V-111  
(2016)

**PETITION No.:** V-111  
**DATE OF HEARING:** 8-10-2016  
**PRESENT ZONING:** O&I  
**LAND LOT(S):** 983  
**DISTRICT:** 17  
**SIZE OF TRACT:** 1.94 acres  
**COMMISSION DISTRICT:** 2

**TYPE OF VARIANCE:** 1) Waive the minimum required number of parking spaces by seven (7) spaces for buildings 294 and 296; 2) waive the side setback from the required 15 feet to 6.1 feet adjacent to the eastern property line for building 294; 3) waive the rear setback from the required 30 feet to 29 feet adjacent to the northern property line for building 294; 4) allow the building to extend 25 feet into 25 foot impervious buffer for building 294; 5) allow the building to extend 36 feet into the 75 foot stream buffer for building 294; 6) waive the side setback from the required 15 feet to 13.8 feet adjacent to the eastern property line for building 296; 7) waive the front setback from the required 50 feet to 36.3 feet adjacent to the southern property line for building 296; 8) allow the building to extend 25 feet into 25 foot impervious buffer for building 296; 9) allow the building to extend 13.3 feet into 75 foot stream buffer for building 296; 10) allow parking lot to extend 25

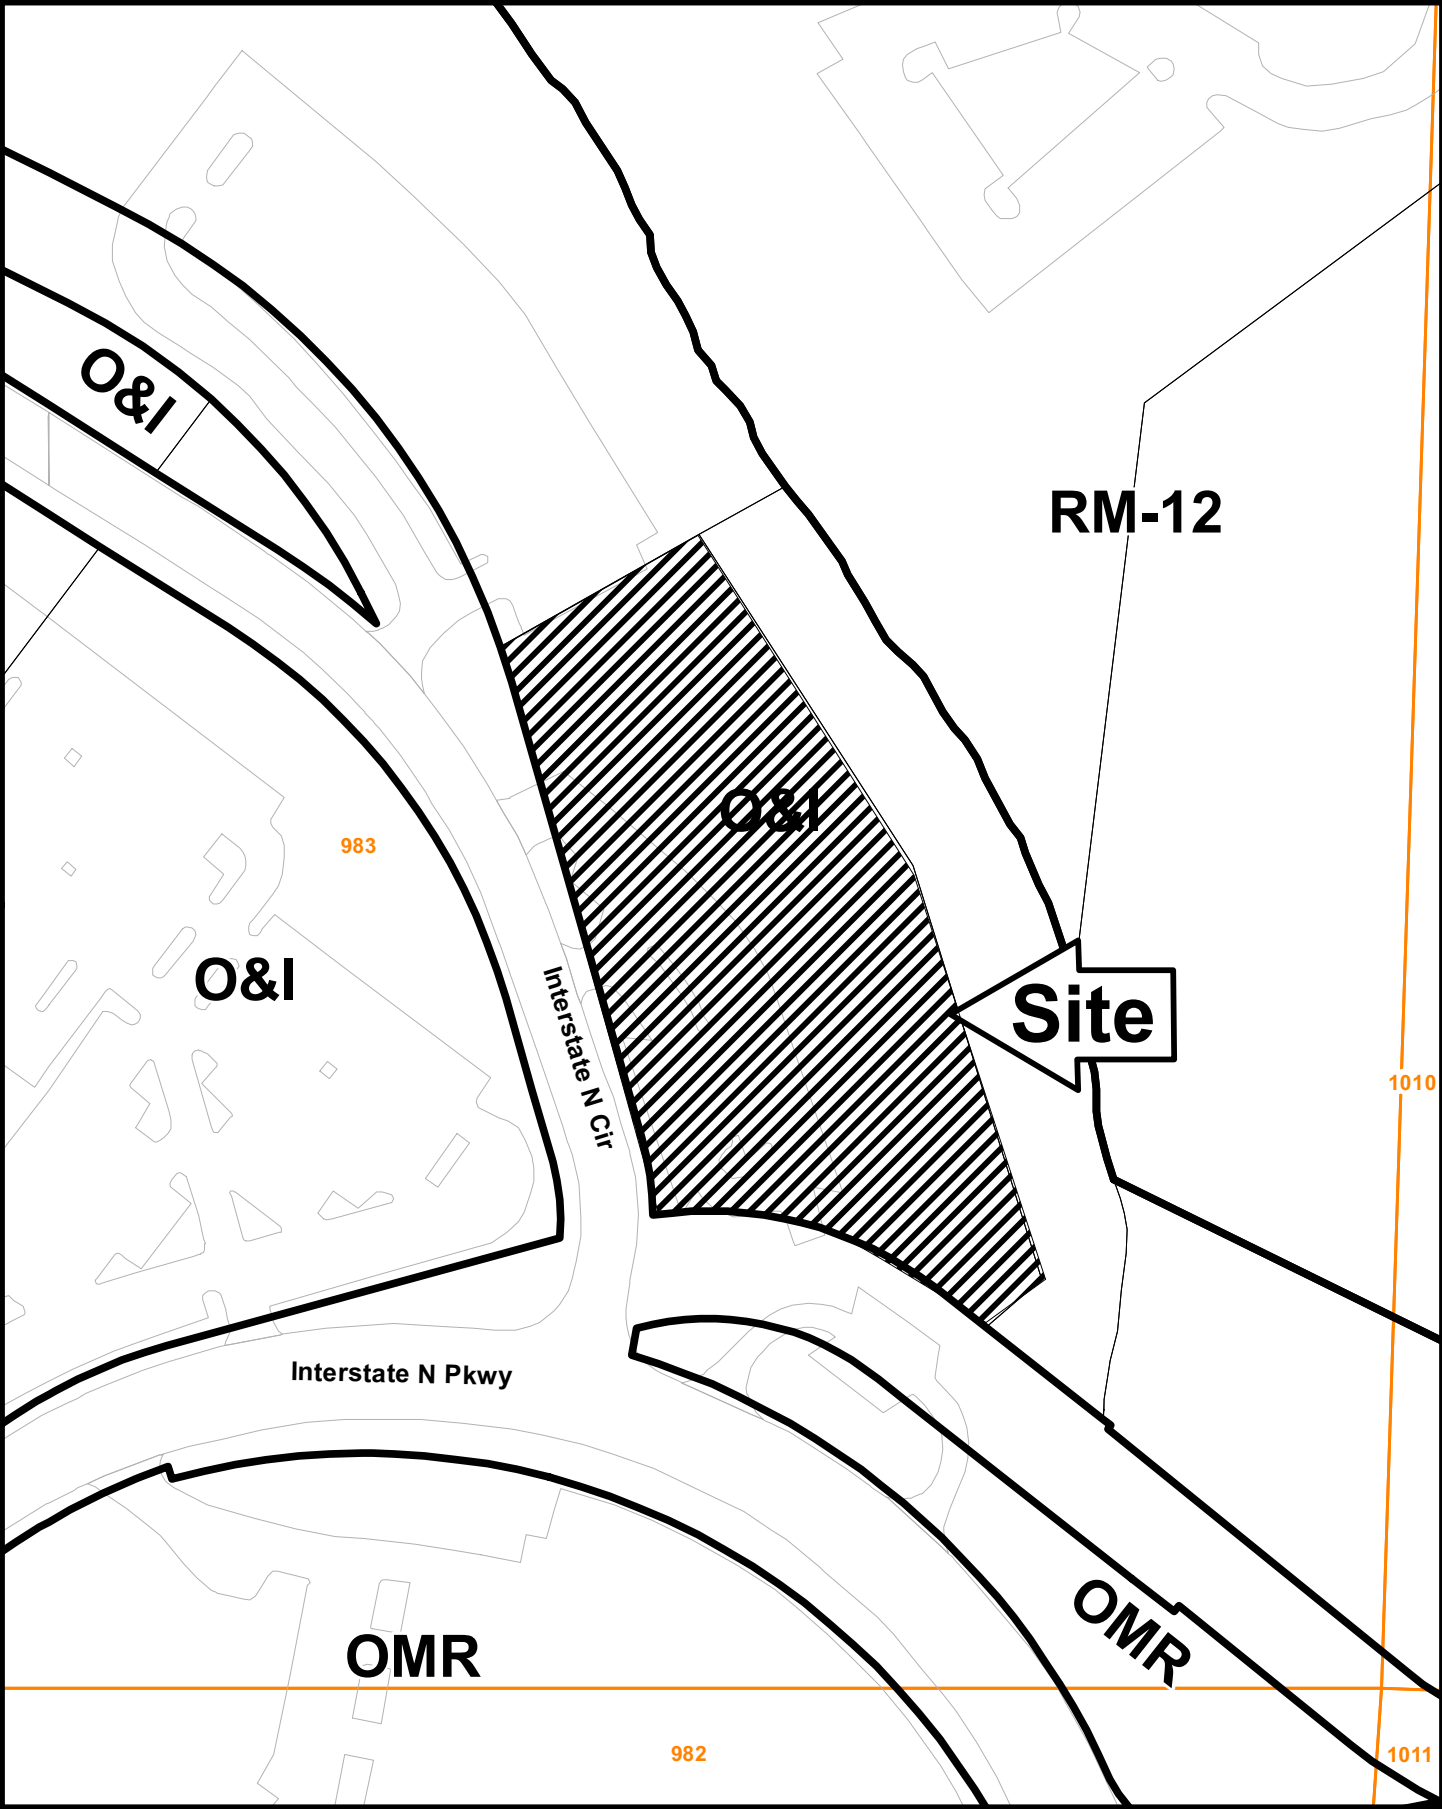
**TRAFFIC:** This request will not have an adverse impact on the transportation network.

**STORMWATER MANAGEMENT:** Subject to approval for existing buffer encroachments only.

**WATER:** No conflict

**SEWER:** No conflict

**FIRE DEPARTMENT:** NO COMMENTS: After analyzing the information presented for a Preliminary Review, the Cobb County Fire Marshal's Office is confident that all other items can be addressed during the Plan Review Stage.
